National Capital Plan – Amendment 87 – Relocation of Indicative Sites for Landmark Buildings (Knowles Place)¹

This instrument is the *National Capital Plan – Amendment 87 – Relocation of Indicative Sites for Landmark Buildings (Knowles Place)*.

[1] Section 4.6 City Hill Precinct Code

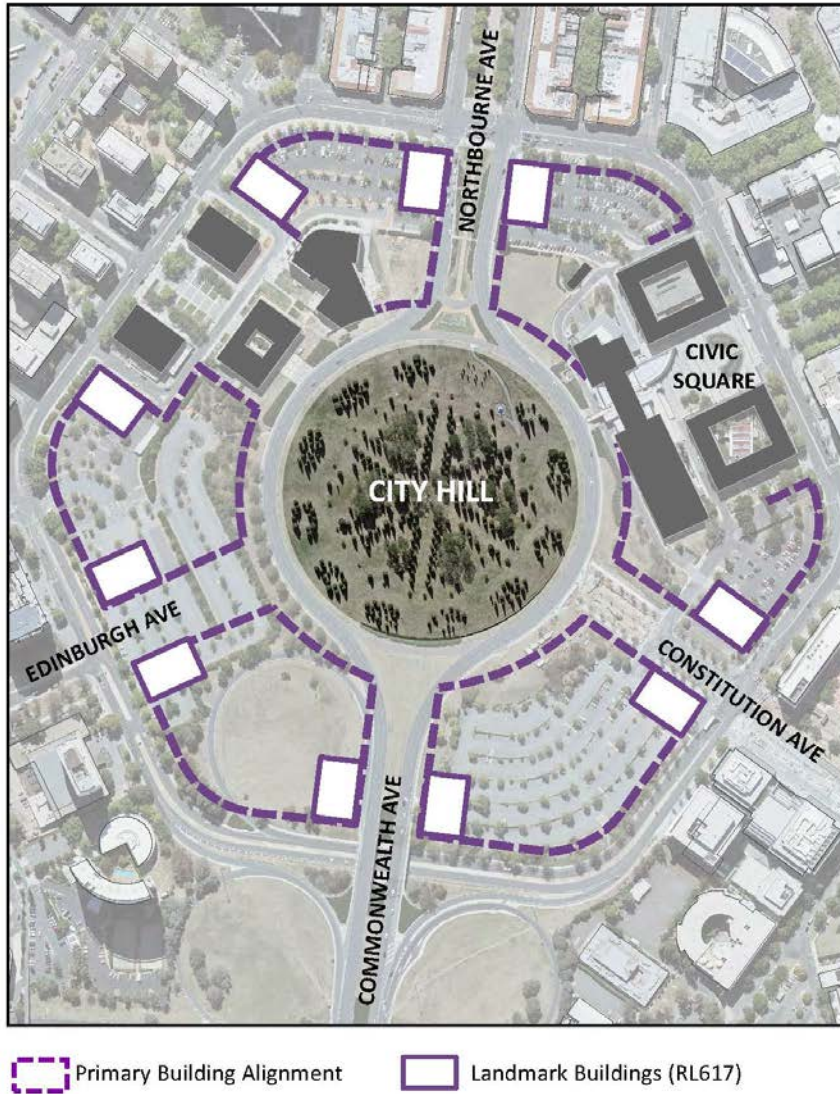
- a. Under the section titled 'Building height', delete the second paragraph and replace with:
Landmark buildings up to RL617 (generally 14 to 18 storeys) will be restricted to the locations identified in Figure 40, generally being the corners of the main avenues intersecting with London Circuit.
- b. Delete Figure 40 and replace with:
